## ZONING CHANGE REVIEW SHEET

CASE: C814-2023-0057 (200 E. Riverside PUD) DISTRICT AREA: 9

ADDRESS: 200 East Riverside Drive

TO: PUD-NP

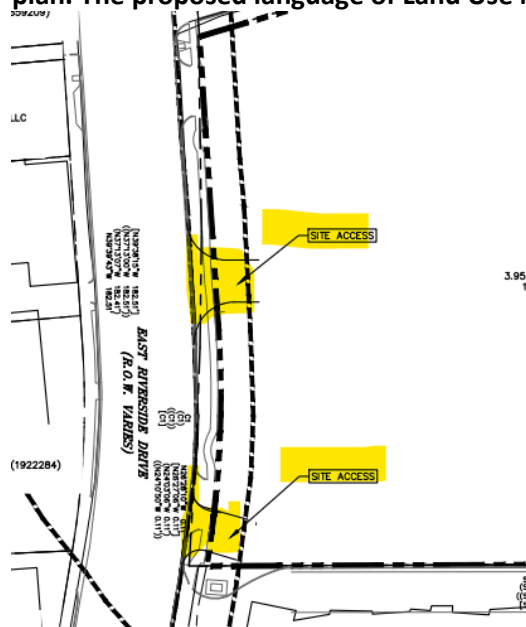
**U2: Comment pending. The TIA final memo states the following:**

*8. Approval of this TIA does not grant nor guarantee approval of proposed driveway locations or driveway types. An updated TIA or addendum may be required at the time of the site plan when more details about the site are available.*

**Accordingly, please remove any reference to site access points from the PUD exhibits or note that they are only demonstrative and subject to review at the time of site plan. The proposed language of Land Use Note #1 should be modified to reflect this.**

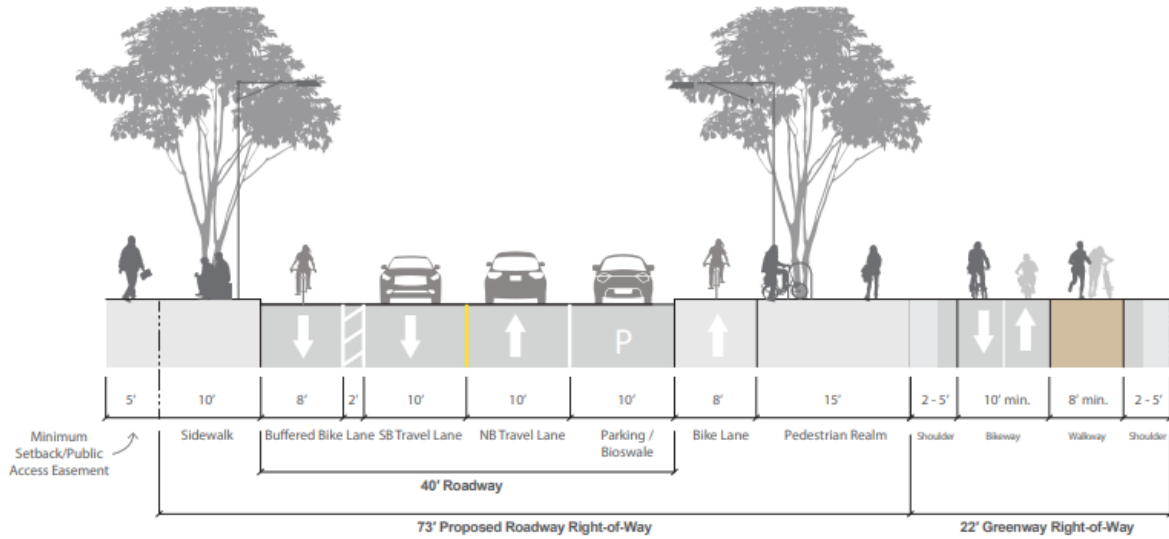
Provides bicycle facilities that connect to existing or planned bicycle routes or provides other multi-modal transportation features not required by code.

Comment pending. TPW supports the application's commitment to coordinating improvements with ATP/Project Connect, however, final recommendation is contingent upon the PUD's commitment to the recommendations of the TIA as well.

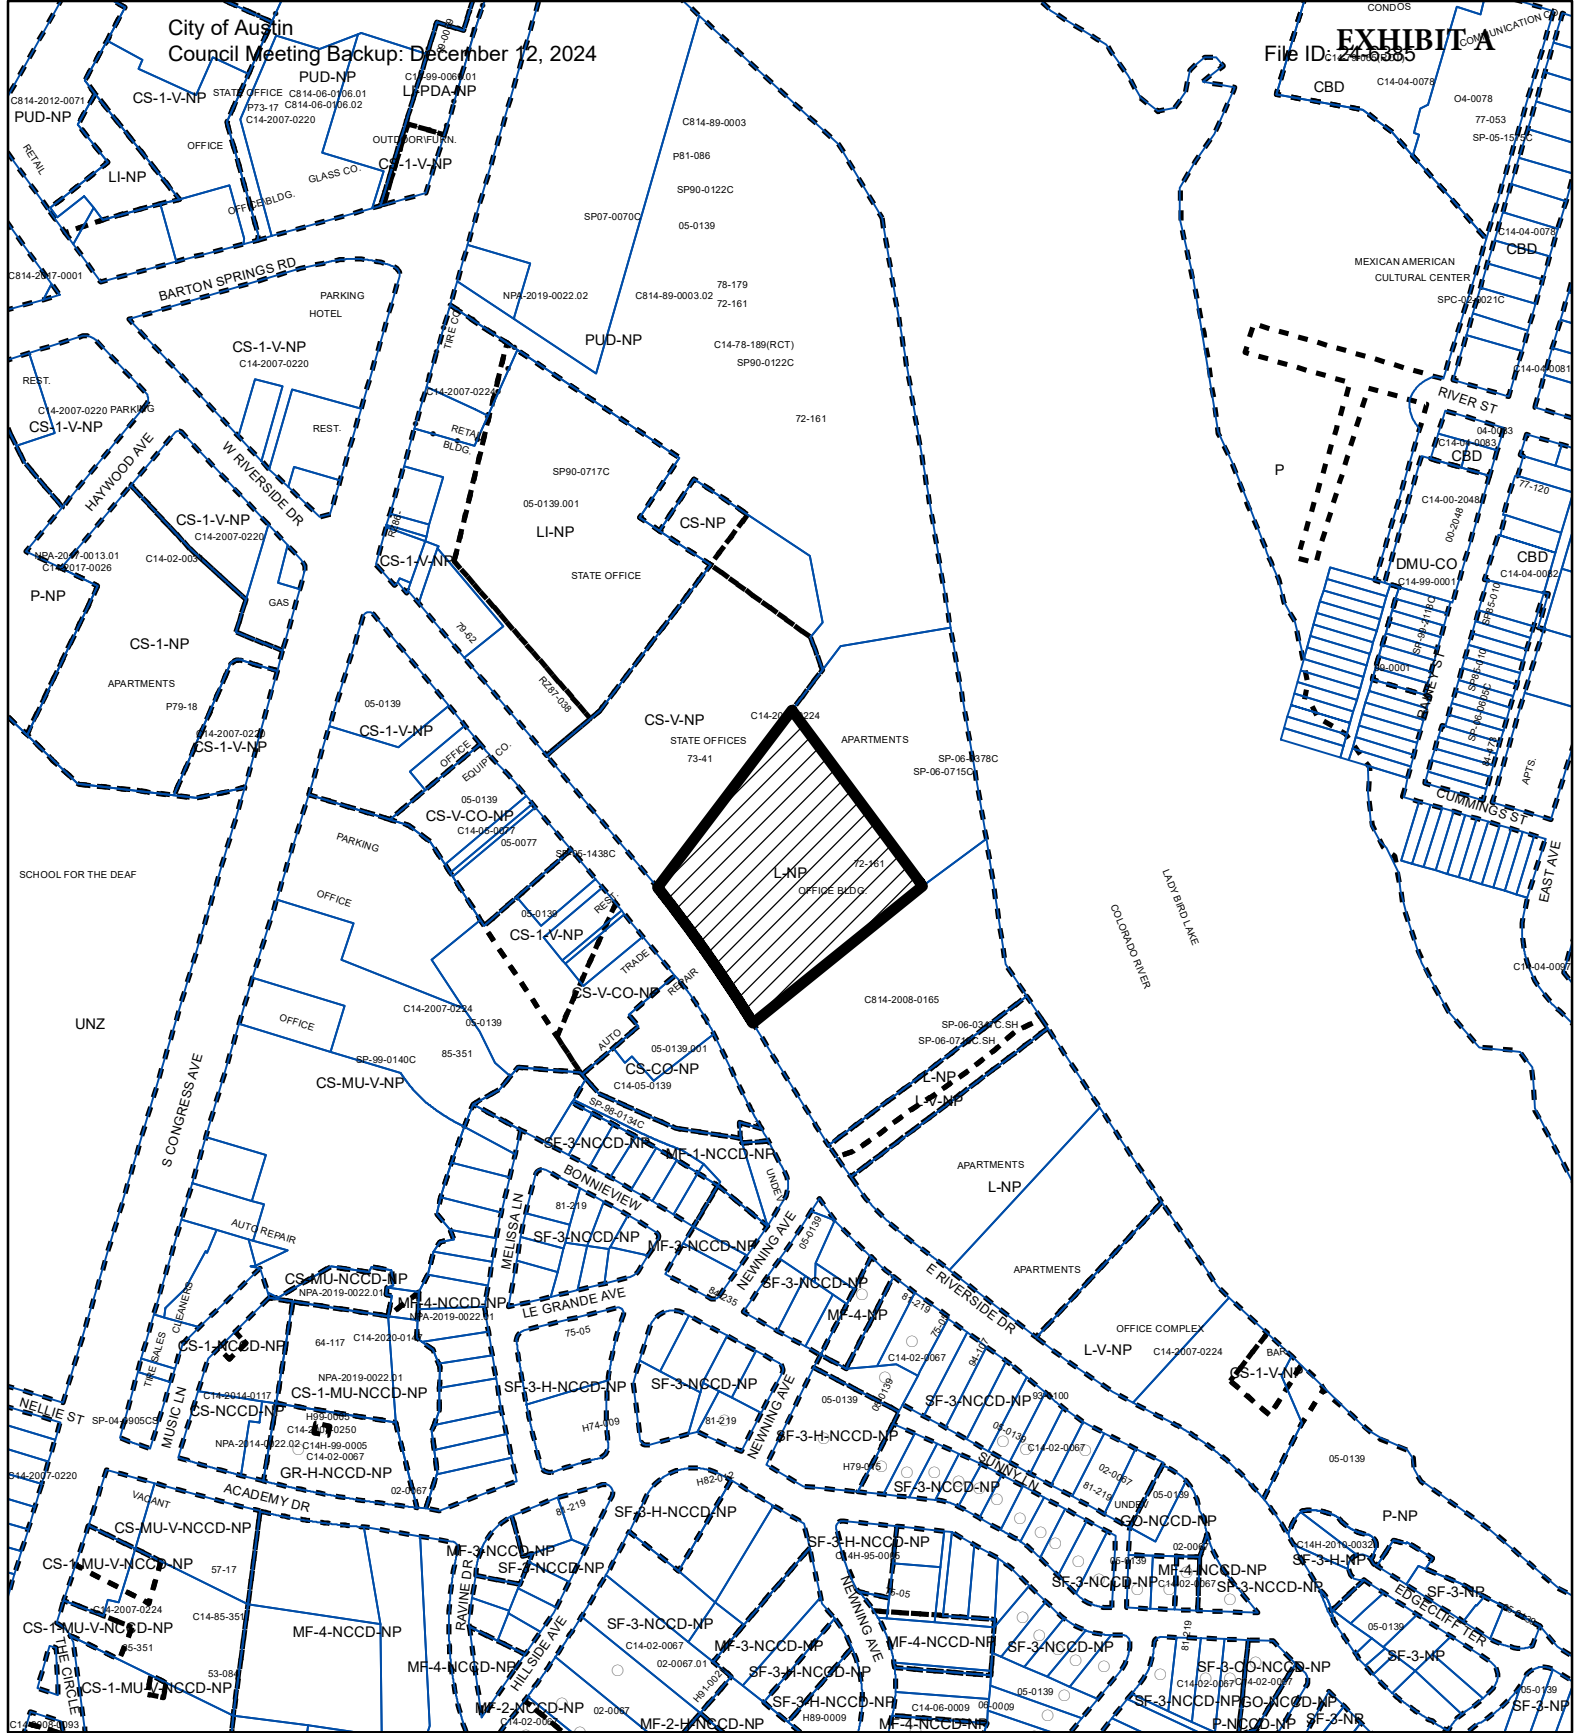
WQ 2. Projects submitted after November 7, 2022, will be required to provide green stormwater control measures to meet water quality control requirements (with some exceptions) in accordance with the recently passed Ordinance No. 20221027-045, Part 18 [25-8-213 (C) and (D)]. Green infrastructure options are outlined in ECM 1.6.7. Administrative waivers may be granted on a case-by-case basis. The ordinance document can be found here (see pg. 24-26 for green infrastructure requirements): <https://services.austintexas.gov/edims/document.cfm?id=399108>.

Per the superiority table provided, green water quality controls as prescribed in ECM 1.6.7 are proposed to treat 50% of the required water quality volume. Please note that the use of green water quality controls as prescribed in the ECM should not be considered superior for the purposes of Tier 2 requirements. Please confirm acknowledgment.
